NE Adm Services
Veteran's Home Garage Addition
APMA Project 12066
January 28, 2013

(600 East Benjamin Avenue, Norfolk, NE 68701)

This addendum is issued by the Owner to all known bidders prior to receipt of Proposal. Bidders shall acknowledge receipt of this Addendum by so indicating on the Proposal Form. All information and instruction given herein shall become a part of the Contract Documents.

V1 FLOOR PLAN - ELECTRICAL
A1.0 SCALE: 1/4" = 1'-0"

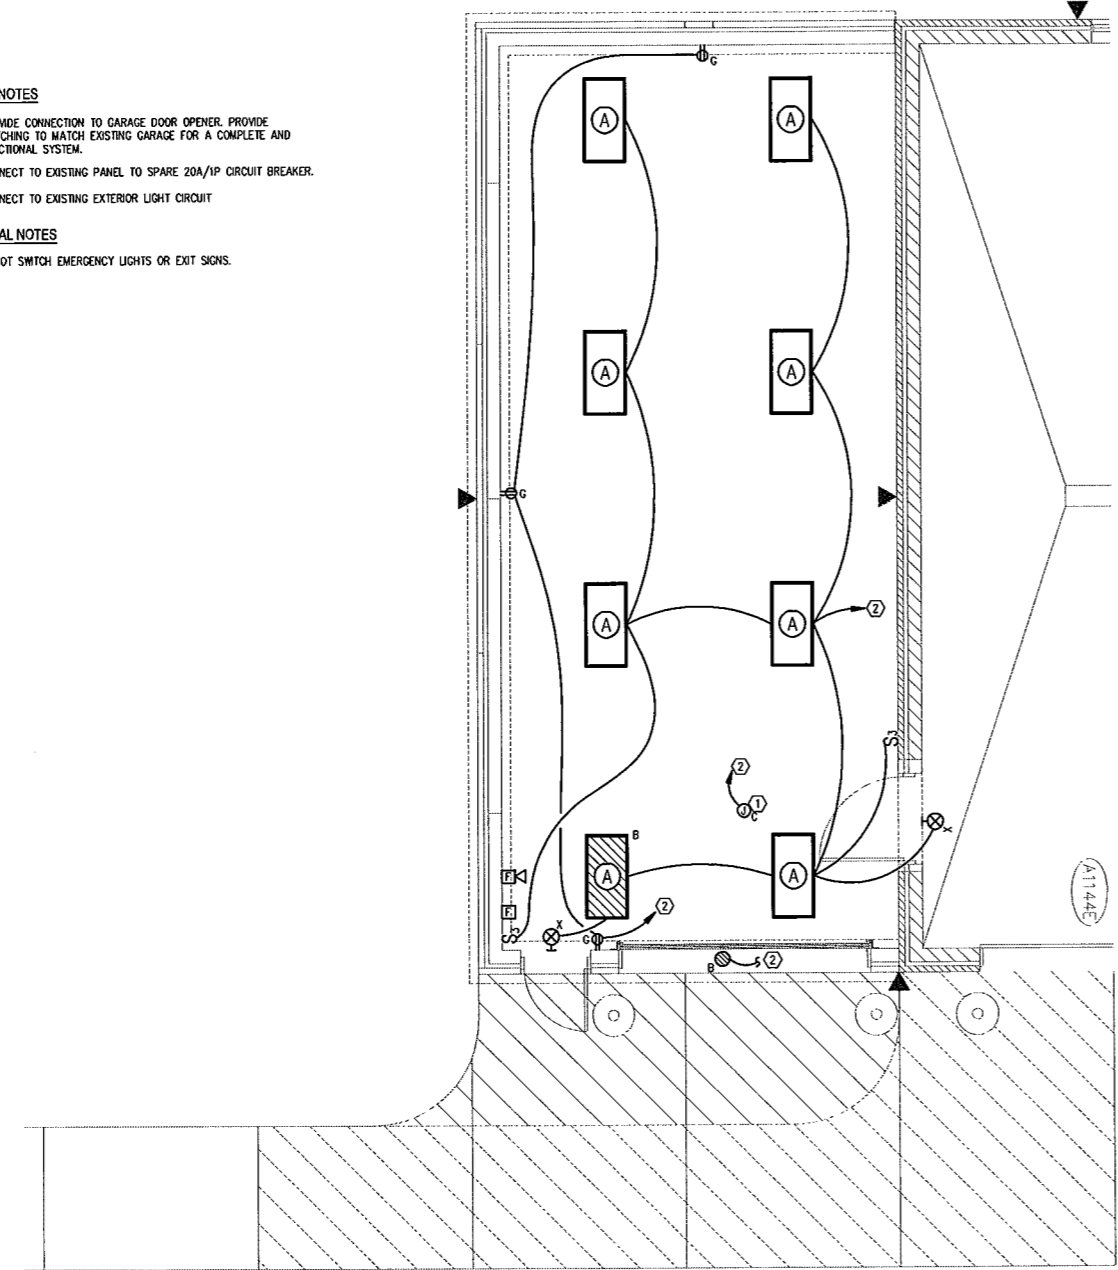
- Q1. Electrical Plan for Addition?
 - a. Add Sheet E1.0 Floor Plan – Electrical. See Supplemental Drawing AD6
 - Q2. Door width should be reduced to 12'?

- AD6. Add sheet E1.0 FLOOR PLAN - ELECTRICAL

SHEET NOTES
1. PROVIDE CONNECTION TO GARAGE DOOR OPENER. PROVIDE SWITCHING TO MATCH EXISTING GARAGE FOR A COMPLETE AND FUNCTIONAL SYSTEM.
2. CONNECT TO EXISTING PANEL TO SPARE 20A/1P CIRCUIT BREAKER.
3. CONNECT TO EXISTING EXTERIOR LIGHT CIRCUIT
